102-07248-MLL/TNW/PJH
April 29, 2016

Subject: **Palo Verde Nuclear Generating Station (PVNGS)
Units 1, 2, and 3
Docket Nos. STN 50-528, 50-529, and 50-530
APS Response to Request for Additional Information Regarding
Overall Integrated Plan for Implementation of Order EA-12-051, *Reliable Spent Fuel Pool Instrumentation***

**Response to NRC RAIs Regarding Overall Integrated
Plan for Implementation of Order EA-12-051, *Reliable
Spent Fuel Pool Instrumentation***

Figure 1

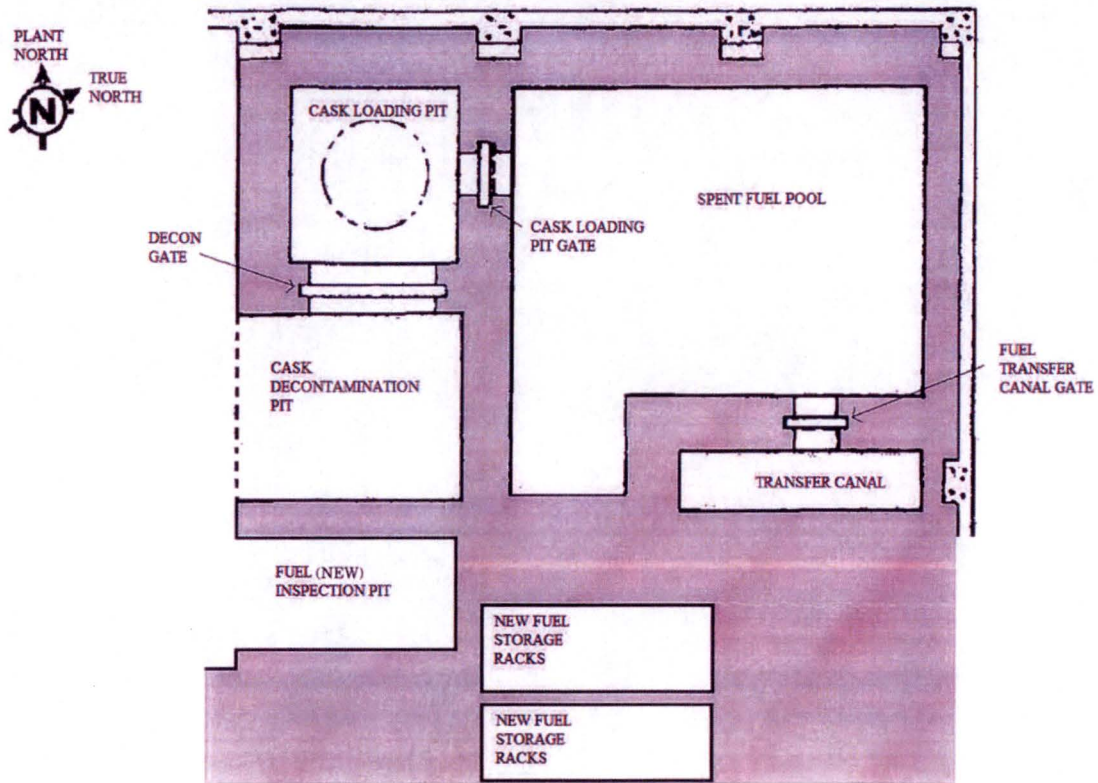
- a) A description of how the other structures in the vicinity of the SFPs (cask loading pit, transfer canals and gates) shown in Figure 2, "Spent Fuel Pool Geometry and Dimensions" are connected to the SFPs.**
- b) If additional structures, other than the SFPs in each unit, are used for fuel storage, describe in detail their usage, operation, and provide justifications for not installing separate level instrumentation in other structures used for fuel storage.**

- a) The Spent Fuel Pool (SFP) is connected to two refueling structures; the Transfer Canal and the Cask Loading Pit, reference Figure 1. A Seismic Category I gate, with dual seals separates the inventory between the SFP and the Cask Loading Pit. A Seismic Category I gate and seal separates the inventory between the SFP and the Transfer Canal. This seal is currently being modified to a dual seal design independent of Order EA-12-051. In addition, a Seismic Category I gate, with dual seals, separates the inventory between the Cask Loading Pit and the Cask Decontamination Pit, which connects to the Fuel Building at grade elevation. This gate is only removed during dry cask campaigns when the gate between the SFP and Cask Loading Pit is installed. The lowest elevation of the gate between the Cask Loading Pit and the Cask Decontamination Pit is 124 feet, 0 inches which is above the top of the SFP storage rack (114 feet, 2 inches). The dual gate seals are pressurized by a redundant air and nitrogen gas supply and have an additional Seismic Category I back-up nitrogen source. The SFP is configured to comply with the requirements of Regulatory Guide 1.13, *Spent Fuel Storage Facility Design Basis*, Revision 0.

Routing of Sensor Cables from Sensor Location to Display Locations
Figure 2

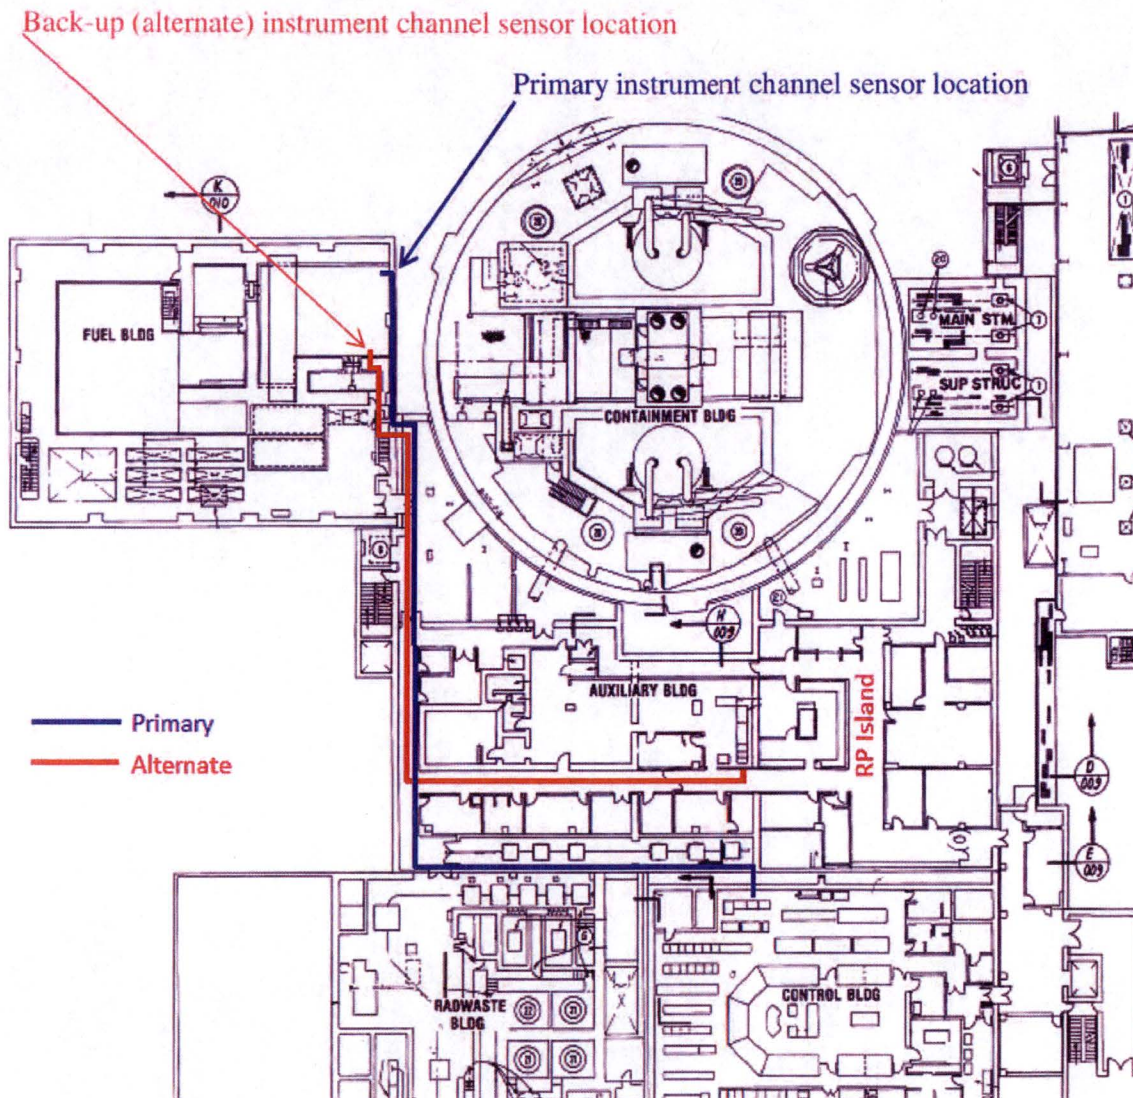
- a) The final locations/placement of the primary and back-up SFP level sensor.**
- b) Additional information describing how the proposed arrangement of the sensor probe assembly and routing of the cabling between the sensor probe assembly and the electronics in the Auxiliary Building meets the Order requirement to arrange the SFP level instrument channels in a manner that provides reasonable protection of the level indication function against missiles that may result from damage to the structure over the SFP.**

- a) The primary instrument channel sensor is mounted in accordance with JN350-A00038 (Reference 17 of this enclosure) in the northeast corner of the SFP on the east wall. The back-up (alternate) instrument channel sensor is located in the southeast corner of the Spent Fuel Pool (SFP) on the south wall, as shown in Figure 2.

The sensors are located close to the side walls of the SFP and below the floor elevation to utilize the pool walls as inherent protection. From the primary sensor, the primary signal cable, contained in rigid metal conduit, is run east along the floor to the east wall of the Fuel Building. The primary signal cable is then routed along the east wall until it penetrates the wall into the Auxiliary Building. From the alternate sensor, the alternate signal cable, contained in rigid metal conduit, is run east along the floor to the east wall of the Fuel Building. The alternate signal cable is then routed along the east wall until it penetrates the

wall into the Auxiliary Building. The raceway containing the signal cables share only a small distance along the common east wall of the Fuel Building where they penetrate the wall and enter the Auxiliary Building.

Once the cables enter the Auxiliary Building they are routed to separate locations prior to connecting to the electronics. The SFP walls and corners provide inherent missile protection for the level sensor cable. See Figure 2 for a depiction of the conduit routing.

Figure 3

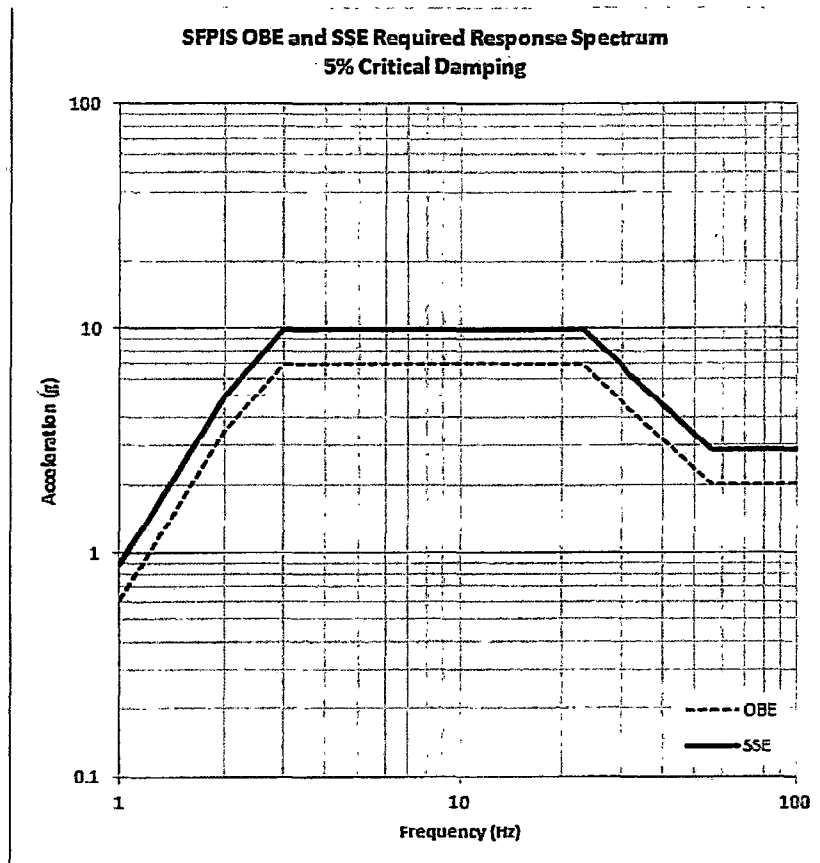
Please provide the analyses verifying that the seismic testing of the sensor probe assembly and the electronics units, and the licensee's analysis of the combined maximum seismic and hydrodynamic forces on the sensor probe assembly exposed to the potential sloshing effects, show that the SFP instrument design configuration will be maintained during and following the maximum seismic ground motion considered in the design of the SFP structure.

Spent Fuel Pool Instrumentation System (SFPIS) Equipment (sensor and electronics): The seismic testing for the Sensor and Electronics is documented in JN350-A00076 (Reference 4 of this enclosure). The seismic testing was satisfied for SSE in accordance with IEEE 344-2004, *IEEE Recommended Practice for Seismic Qualification of Class 1E Equipment for Nuclear Power Generating Stations*, Required Response Spectra (RRS) to IEEE 323-2003 with 10% margin included. SSE is shown in Figure 3. The Operating Basis Earthquake (OBE) RRS at 5% critical damping was at least 70% of the respective SSE seismic level of Figure 3.

The sensor and electronics met each of the required performance and acceptance criteria, maintained structural integrity during the acceptable SSE test runs, and acceptable OBE test runs to the RRS. Acceptable functionality of the electronics and
